Updated Field Safety Notice**MR systems with 60cm wide bore**

Quadrature Body Coil (QBC) seal adhesive failure may result in exposure of sharp edges

Updated Field Safety Notice

Quadrature Body Coil (QBC) seal adhesive failure may result in exposure of sharp edges

Figure 1. QBC seal location

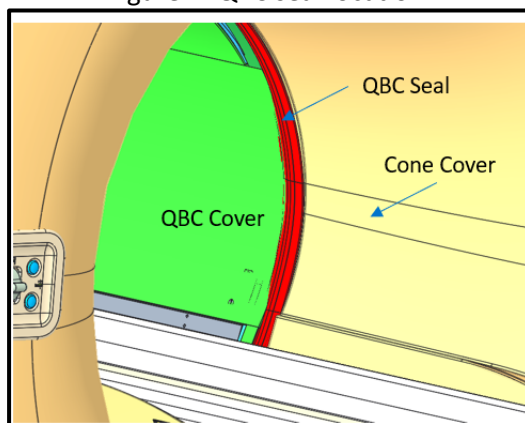
The Quadrature Body Coil (QBC) seal adhesive may fail creating sharp edges that may come in contact with patients. The QBC seal may become loose as the patient table travels in a horizontal motion in and out of the system bore. The QBC seal (Figure 1) is a rubber seal that is glued between the cone cover and QBC cover and functions to prevent sharp edges of the QBC cover from contacting patients during an examination.

- As part of the preparation before a patient scan:
 1. Inspect the QBC seal for separation between the cone cover and QBC cover.
 2. If QBC seal is found detached or loose, **Stop-use immediately.**

Philips will contact you to schedule a time for a Field Service Engineer (FSE) to visit your site and replace your system's QBC Seal (reference FCO78100573, FCO78100615).
